GROUP 12 SHEET METAL AND BUMPERS

Figure 12-1

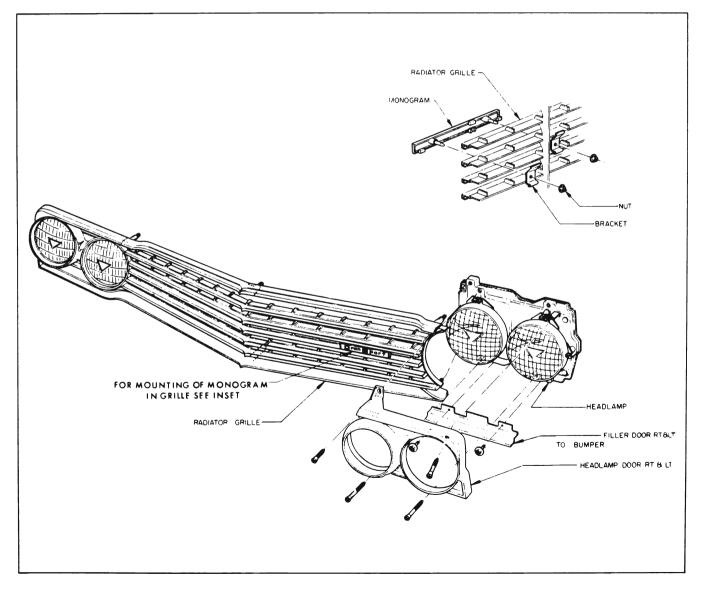
The grille will be the same design now used on Specials and Skylarks, with the exception of an ornament added to the left side. The grille will be painted black where it is now painted silver. The radiator is a new cross-flow design with filler and cooler lines on the left side requiring new radiator mounting panels. The battery will be mounted on the left side of engine compartment. The frame is basically the same as used on convertible (67) styles with the addition of a reinforced rear upper control arm cross member to take the increased engine torque. Body mount locations 1 and 2 will use Sportwagon mounts. See illustrations for grille, radiator and battery changes.
